# SERVICE BULLETIN No. 292 72 2218

Version: C

**Subject:**  
Module M05 - Replacement of the front and rear bearings of the intermediate gear.  
Modification TU 218.

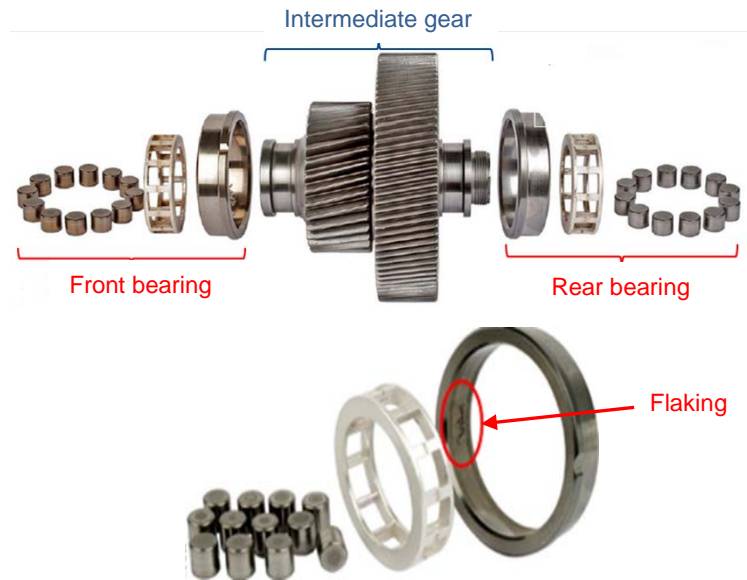
ARRIEL 2 operators reported cases of chips on the module M05 (reduction gearbox).

Investigations of modules M05 removed from ARRIEL 2 engines after chip detection, predominantly show flaking from front and rear bearings of the intermediate gear.

Modification TU 218 introduces a change in the component material of the two bearings in order to improve their mechanical strength.
